# UNITED STATES PATENT AND TRADEMARK OFFICE

10/578,644

<b>Office Action Summary</b>	<b>Application No.</b> 10/578,644	<b>Applicant(s)</b> BACHMANN ET AL.	
	<b>Examiner</b> WALTER H. SWANSON	<b>Art Unit</b> 2823

## DETAILED ACTION

**FIG. 7**

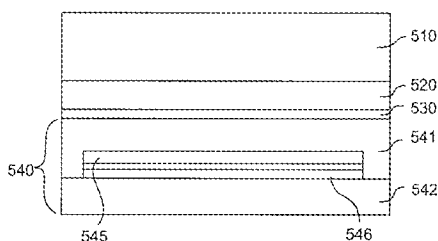
Jones **teaches** an interlayer (545, 546) between the first barrier layer (542) of a first amorphous carbon modification and a second barrier layer (541) of a second amorphous carbon modification (FIG. 7).
